Amendment C205

Hume Planning Scheme

Expert Urban Design Evidence

February 2018

Figure 5: Plan 5 taken from Lindum Vale PSP (Exhibited Version)

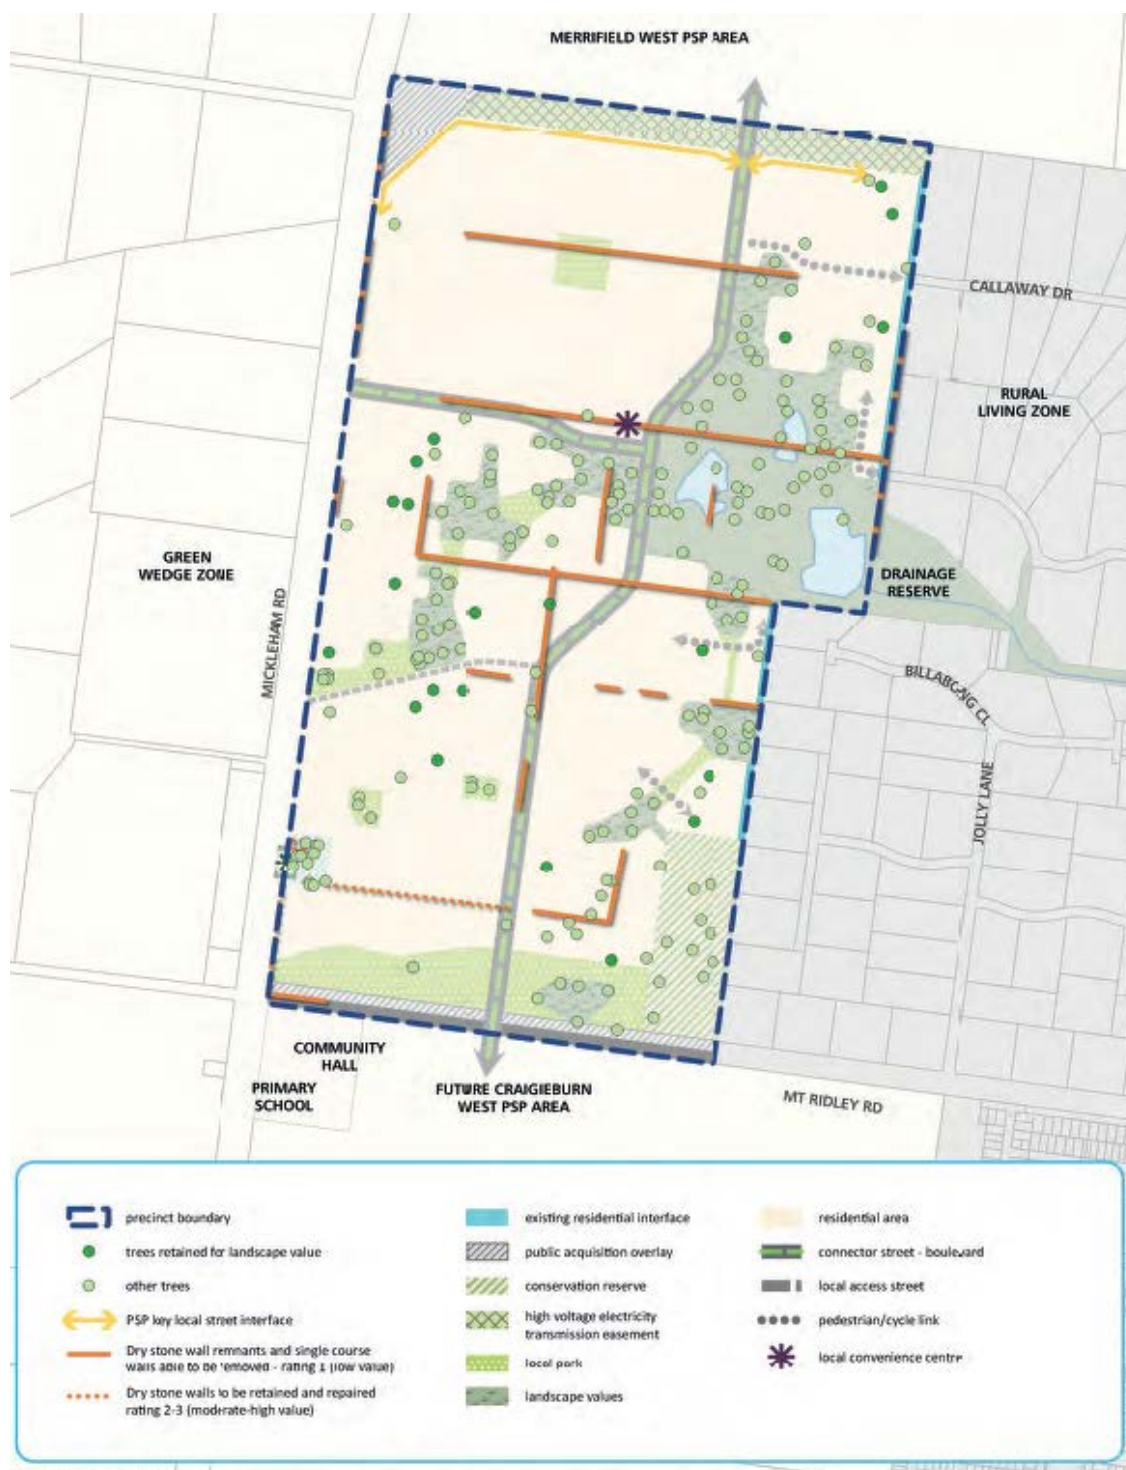
- [36] Following exhibition of the PSP, a revised Urban Structure Plan was prepared and circulated on the 16th of January (Revised Plan 3 – Future Urban Structure). Significant changes were made to the areas set aside for the waterway and drainage reserve to allow for a decentralised drainage system. This has had a flow on affect to the location of local parks and landscape value areas.

- [37] In my view, the changes required to decentralise the drainage system have allowed the areas set aside for waterways and drainage to be more definitive and responsive to natural features. Furthermore, the areas set aside for landscape values have also been redefined, focusing on the trees to be retained but also ensuring green links, particularly the north-south link, extends right through the PSP unbroken.

[43] The Exhibited Future Urban Structure proposed pedestrian/ cycle links extending from these roads into the site. The pedestrian/ cycle link from Callaway Drive is proposed to extend to the north-south connector boulevard. The pedestrian/ cycle link from Cooinda Avenue extends to the edge of the drainage reserve and then terminates. I recommend any pedestrian/cycle links shown on the PSP connect to a green link or road, rather than terminating.

[39] In summary, I support the revised Revised Plan 3 - Future Urban Structure in relation to the shape and spread of local parks and landscape values, as it creates a continuous link through the PSP in a north-south direction. To capitalise on the strategic importance of this link, I recommend the implementation of linear trails connecting pedestrians and cyclists to the Mount Ridley Woodland Nature Conservation Reserve to the north and the BCS conservation area to the south. The indicative passive recreation network should be shown on the Urban Structure Plan as shown in the plan prepared below.

[40] It is also recommended that additional guidance is added to the PSP to a minimum width is applied to the green link to ensure it creates a meaningful urban forest from the north to the south. The green link should be a minimum of 30 metres, excluding a shared path for cyclists.

Figure 8: Scenario 1 – Standard density residential lots

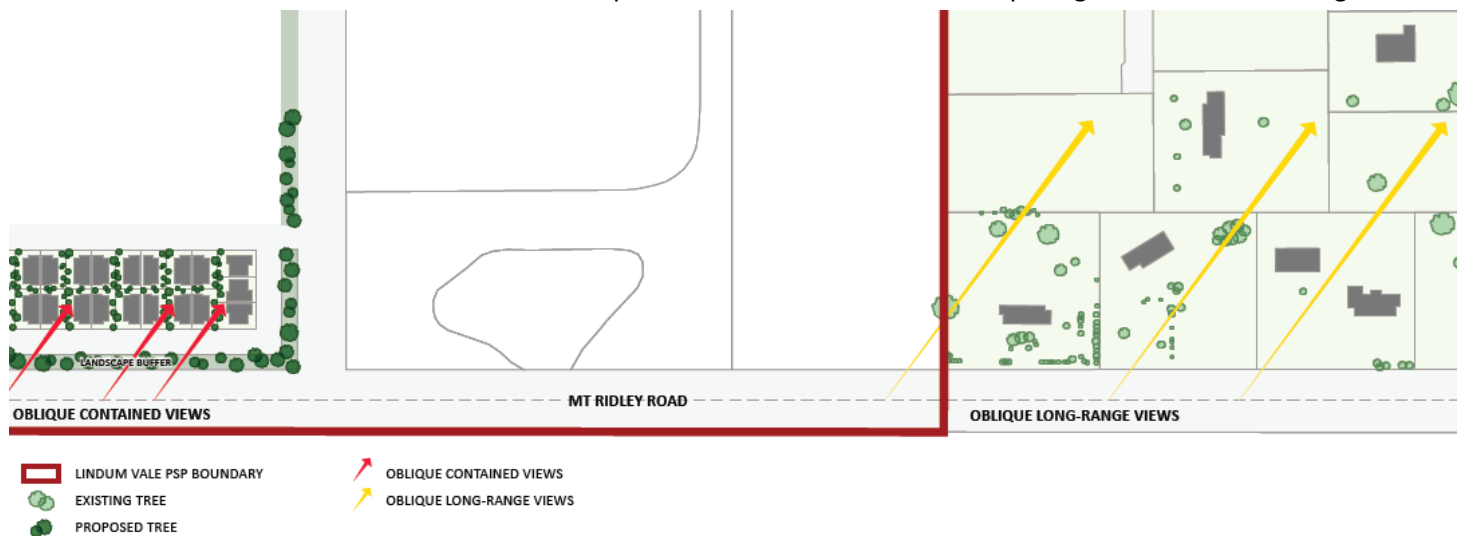
- [55] Scenario 1 shown below tested a standard residential density lot design applying following dimensions:
- Lot area of approximately 400m²;
 - Side setback of 5 metres to one side;

- 5 metre front and rear setbacks;
 - Local frontage road (as per VPA Part A Submission – Figure 6); and
 - Landscape zone to Mt Ridley Road (as per VPA Part A Submission – Figure 6).

- [56] Scenario 1 was then plotted on a plan which shows the standard residential density lots in the context of the existing low density residential subdivision to the east and the difference in oblique views

along Mt Ridley Road. As you will note below, the existing low-density subdivision and its large lots allow for oblique long-range, open views. The reduced density allows you to perceive the spaces and landscape between the built form and therefore the rural landscape character.

[57] Applying a standard residential density to the frontage of Mt Ridley Road does not respond to the rural character existing in other parts of the Inter Urban Break. As identified below, the oblique views from Mt Ridley Road of standard residential density are short and contained. The addition of the road and the landscape buffer, which equates to approximately a 30-metre setback from Mt Ridley Road, only improves the range of the oblique views slightly. The main inhibitor to achieving a more open landscape is the size of the lots and the spacing between the buildings.

Figure 9: Scenario 2 – Larger residential lots

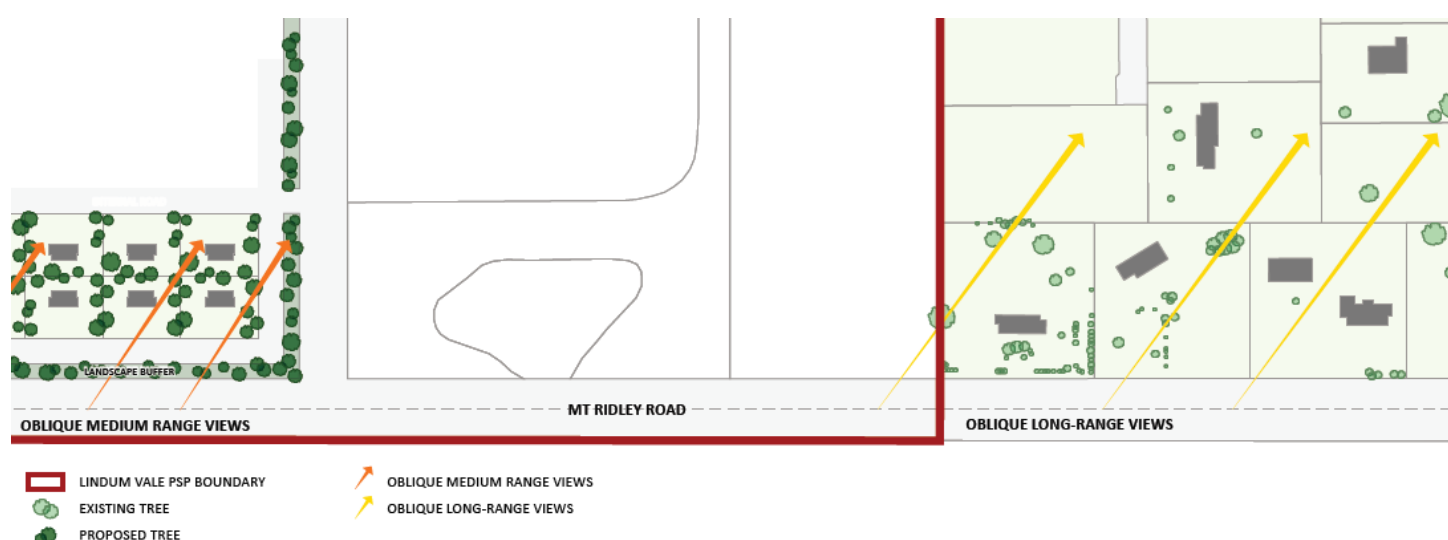
[58] A second scenario was also tested. Scenario 2 shown below tested larger residential lots with the following dimensions:

- Lot area of approximately 2,000m²;
- Side setback of 10 metres;
- Front setback of 20 metres;
- Local frontage road (as per VPA Part A Submission – Figure 6); and
- Landscape zone to Mt Ridley Road (as per VPA Part A Submission – Figure 6).

- [59] As you will note from Scenario 2, the oblique views are much longer and more responsive to the rural landscape character of the adjoining inter-urban break.

- [60] In summary, intrinsic to the landscape value associated with the inter-urban break is visual openness. To achieve openness and longer-range views, the lots fronting Mt Ridley Road need to be larger, creating greater spacing between buildings for landscape and environmental values.

- [62] Based on Scenario 2 above it is recommended that guidelines are introduced to the PSP requiring the following along parts of Mt Ridley Road and Mickleham Road, and along the eastern boundary of the PSP to the north of the Hume City Council drainage reserve:

- A lot width minimum of 50 metres;
 - A lot depth minimum of 40 metres;
 - Local frontage road (as per VPA Part A Submission – Figure 6); and
 - Landscape zone to Mt Ridley Road (as per VPA Part A Submission – Figure 6).
